Product Change Notification

PCN #: 20210903-01

Change Title: AZ8521 housing material change

Before change:	**After change:**

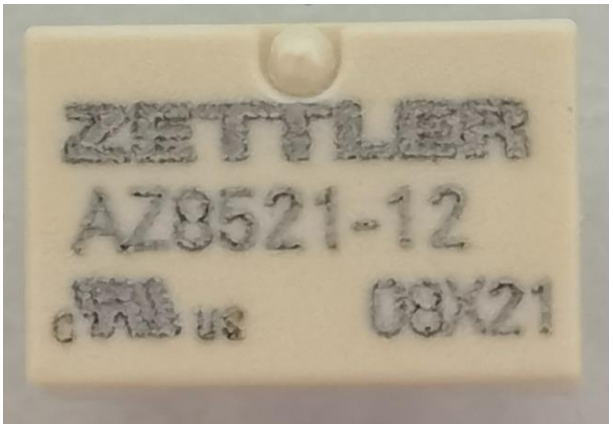
Detailed description:
In order to offer the best delivery times and high-quality service, with this modification we are trying to reduce the risk of the raw material supply chain. The plastic material of the housing is changed from PBT plastics to higher performance LCP plastics, which is used in high volumes in the factory.
The modification does not affect the electrical performance and ratings of the components. Safety certifications are not affected. There is a slight difference in the color of the LCP material.

Cover material: PBT Color appearance: white	Cover material: LCP Color appearance: white (slightly beige)
